## HARTING Electric Product Change Notification PCN/0020

**Product Range:** Han-Modular  
Han E Protected Module

Date: 20131011

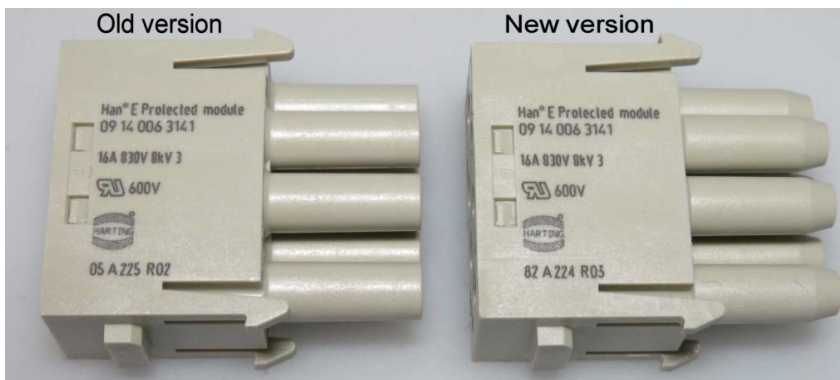
Please be informed that the design of the Han® E Protected Module female 09 14 006 3141 has been changed so that the handling is improved.

- The new design has now a lead-in chamfer that avoids interferences with the male module, which have occurred in the docking frame in some minor applications.
- All other mechanical and electrical characteristics remain the same. The module is 100 % mating compatible.
- The part number remains the same only the revision level is changed from 02 to 03.
